## Technical Note

Project:	Hilfield Solar farm Glare and Glint Study		
Subject:	Review of applicants Glare and Glint Study		
Author:	David Mooney		
Date:	28/05/2021	Project No.:	5193383
Distribution:	Max Saunders	Representing:	Hertsmere Council

Atkins have been commissioned to provide a 3<sup>rd</sup> party review of the Glare and Glint Study (G&G) produced for Enso Energy by Pager Power covering the proposed Solar Farm Development adjacent to Elstree Aerodrome. The documents under review are: -

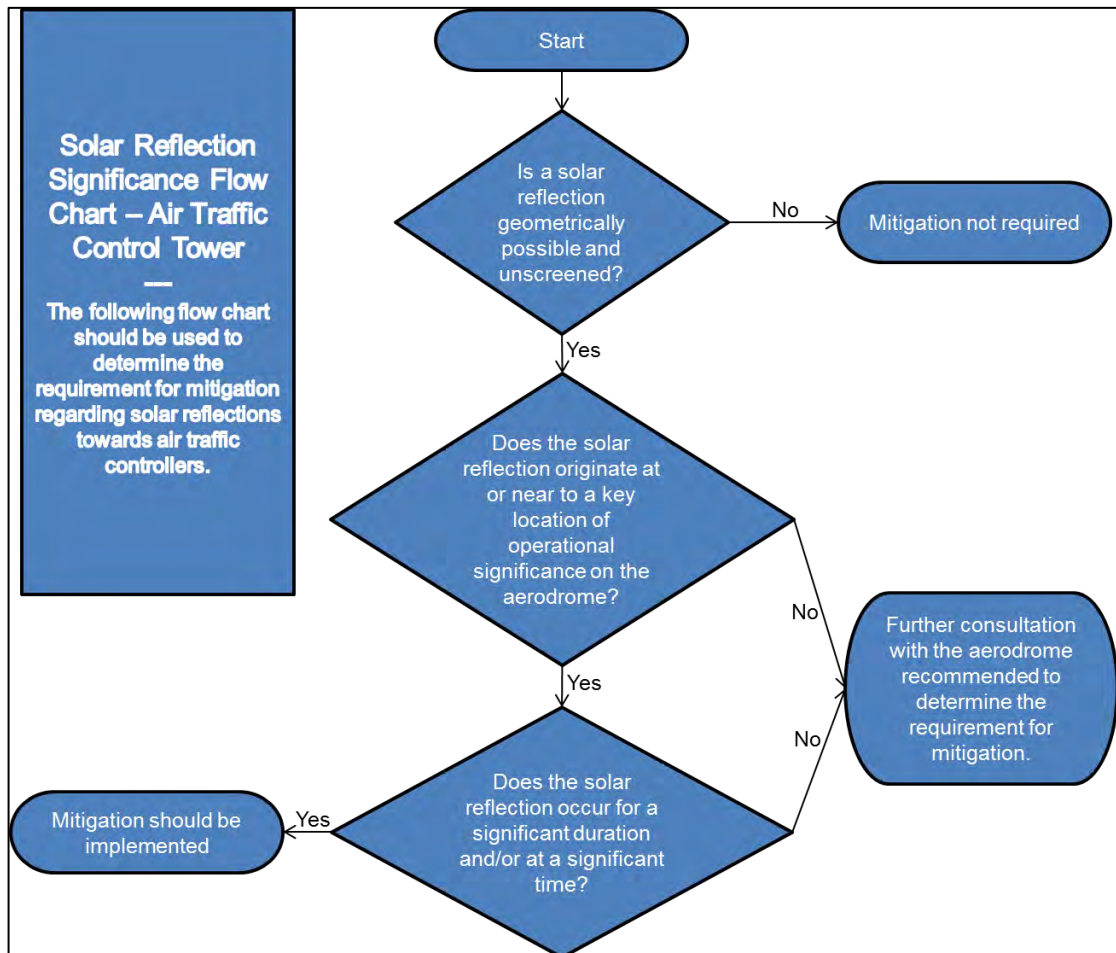
We would consider the impact significant and either moderate or major impact due to the possibility of after image to the pilots and the findings of this report be discussed with Elstree Aerodrome as to whether mitigation is required.

Road receptor mitigation requirement flow chart

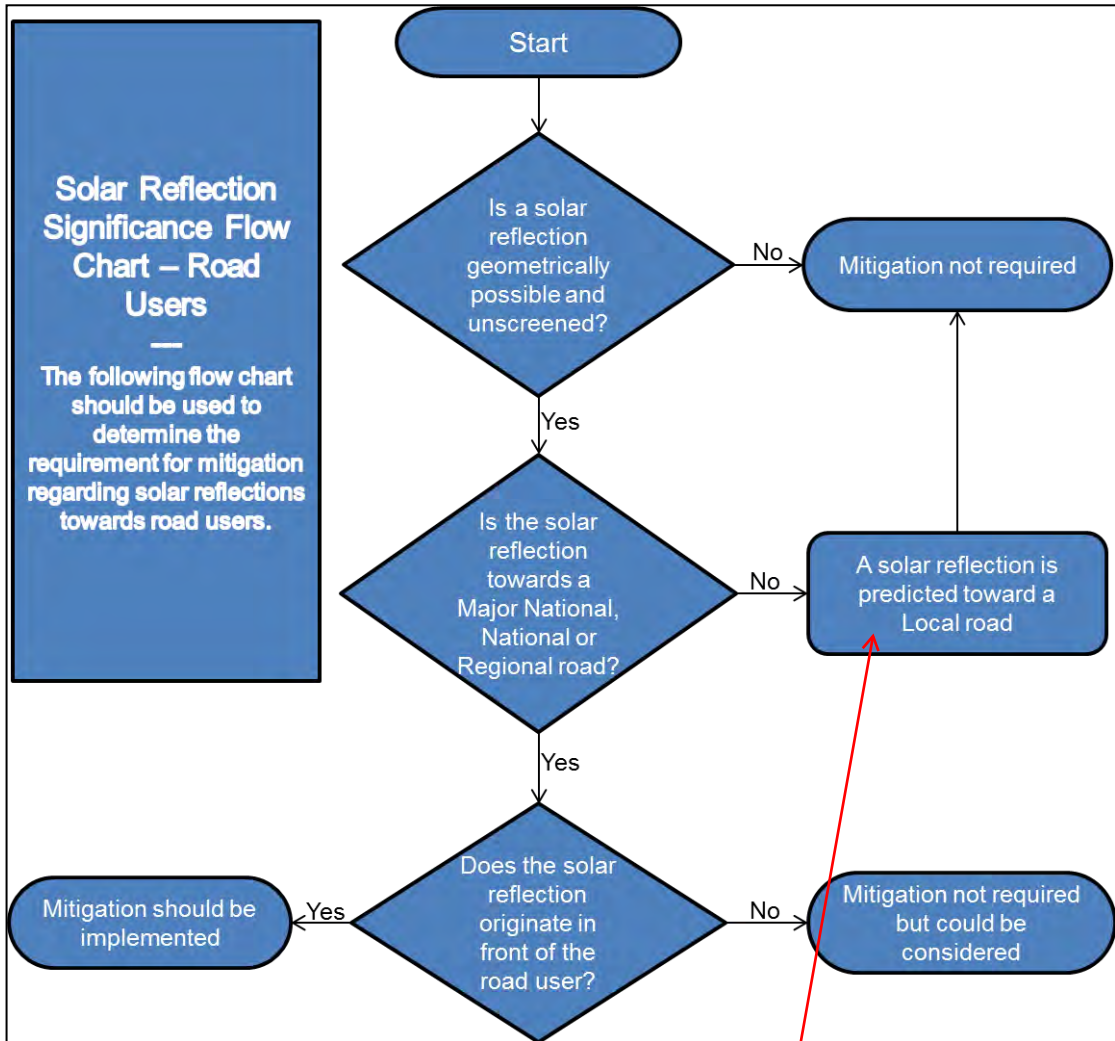
- a. Aviation process no comment.
- b. Assessment process road users this flow chart does not take into account the fact that Highways England consider local roads to be the most dangerous.

Dwelling receptor mitigation requirement flow chart

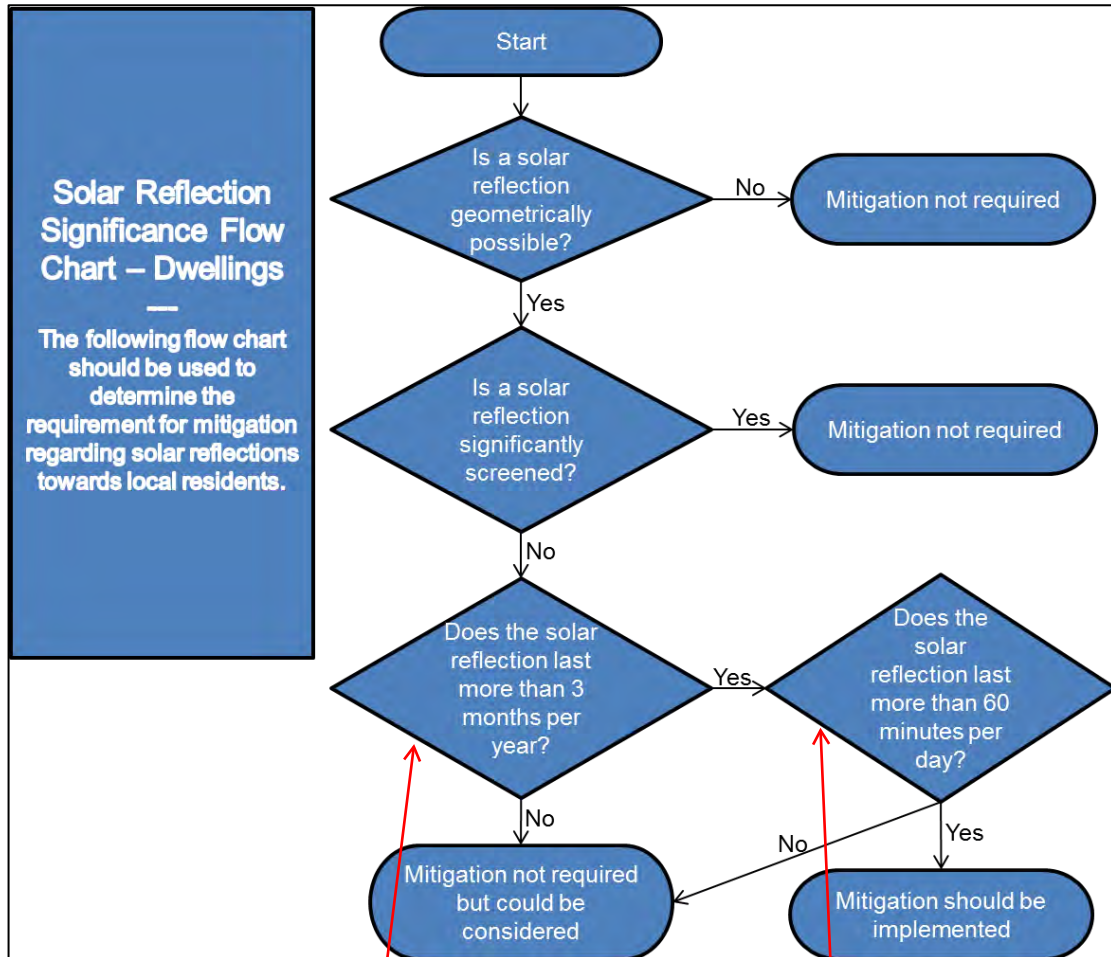
- c. Dwelling receptors assessment process why is less than 3months/year insignificant and why is a duration of 60min considered for mitigation. It only takes less 10minutes to wake someone with sunlight.

## PV array 1 - Receptor (Approach 08)

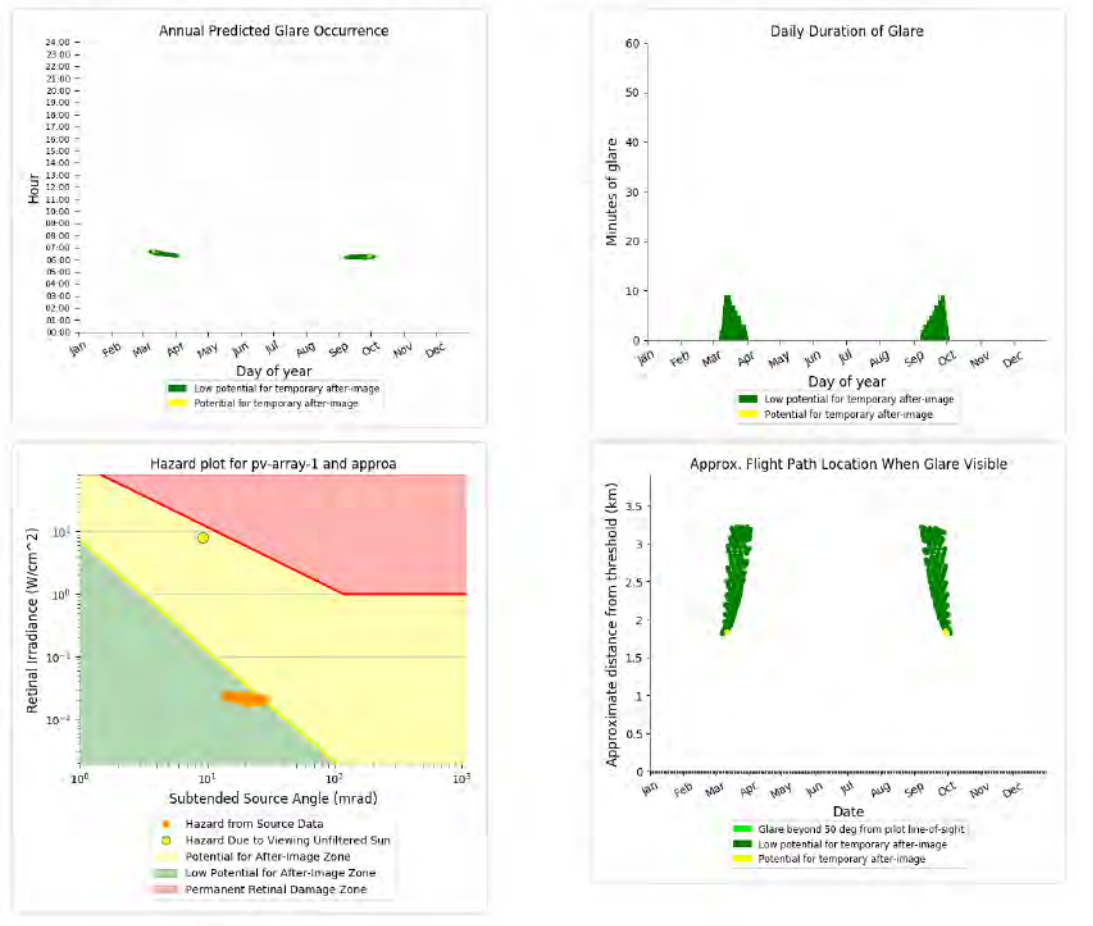
- a. When there are multiple lines on the graphs, are these from multiple panel locations?
- b. Page 192 approach 08- the diagram does not appear to say when the 3minutes of yellow glare appear in the year.
- c. Page 204 yellow glare for approach 26 is seen to occur for 6 approx mins per day max for two months (60 days). These findings should be highlighted in the text of the report.
- d. Page 205
- e. It is noted that these are only the dwelling receptors that are receiving moderate impact.
- f. Page 206 the probable glare is for in excess of 3 months but there is no duration indicated.
- g. Page 207 Why are the gaps in the blue lines?  
As comment g.

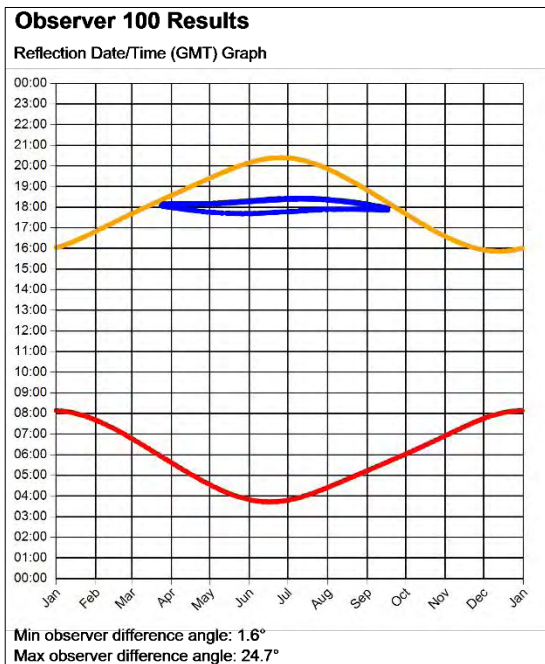
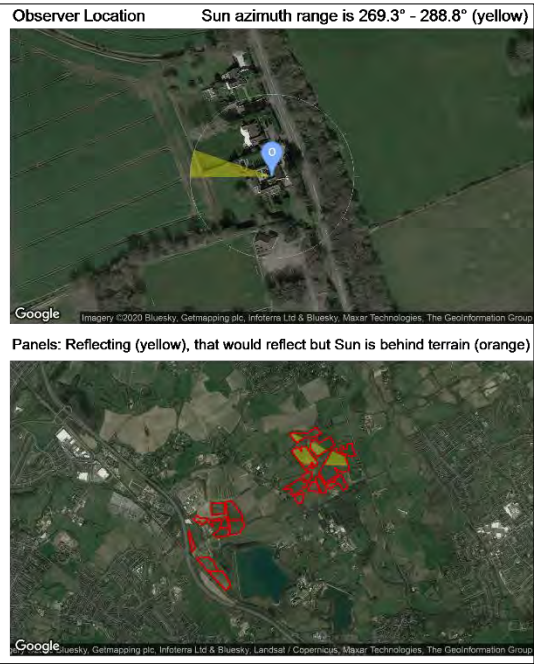
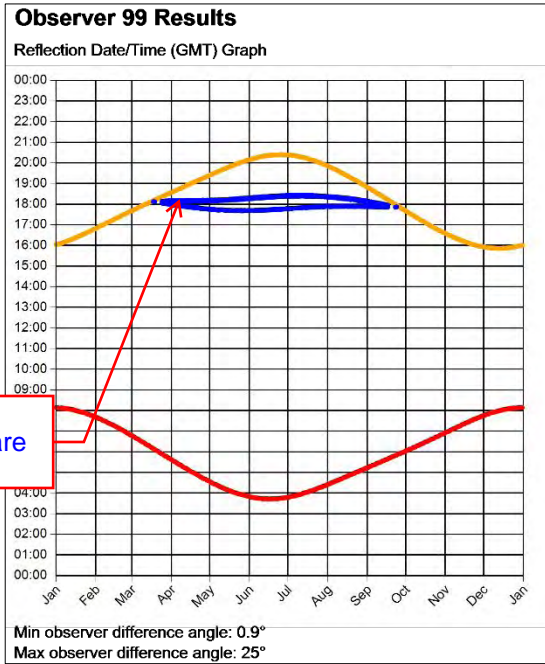
what is the time duration of the glare each day.

## APPENDIX I - LEEP PLAN

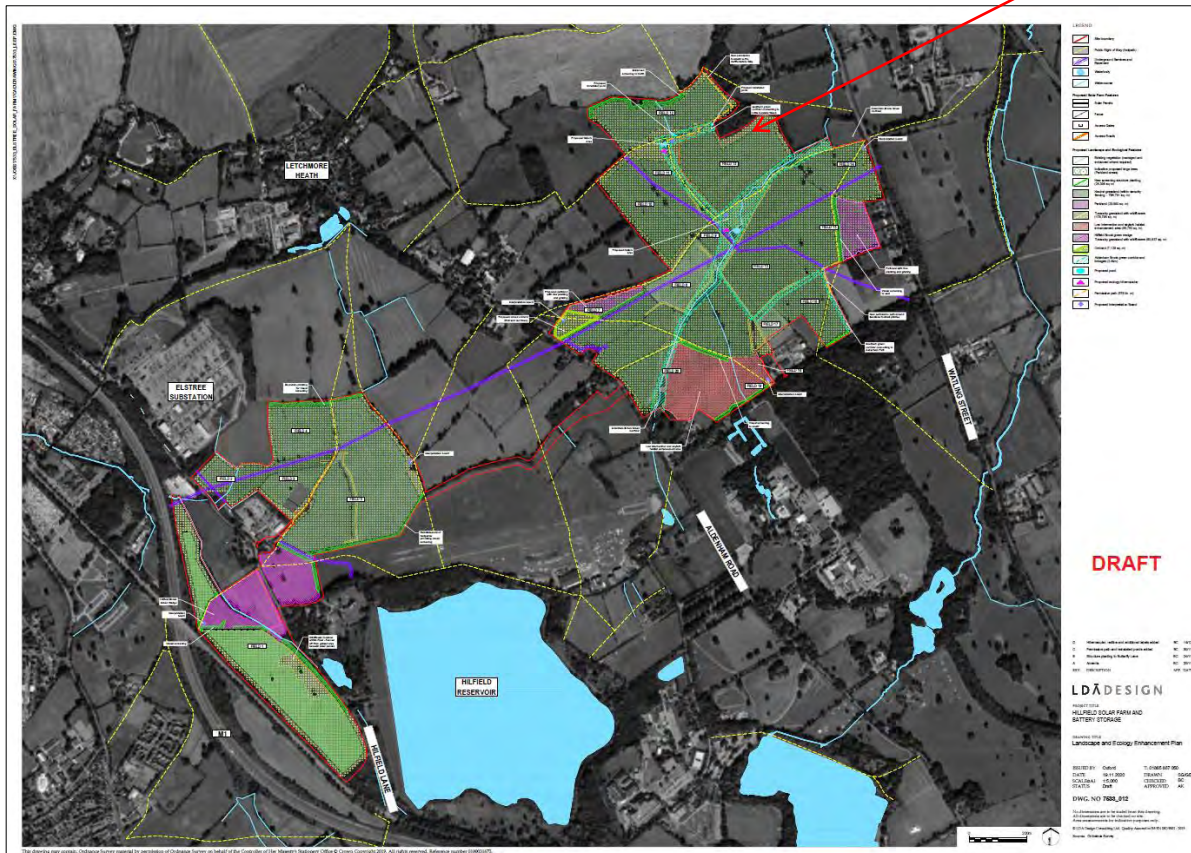
This LEEP diagram is unreadable and not cross referred to anywhere in the text (i.e. see appendix I).

This is unreadable.
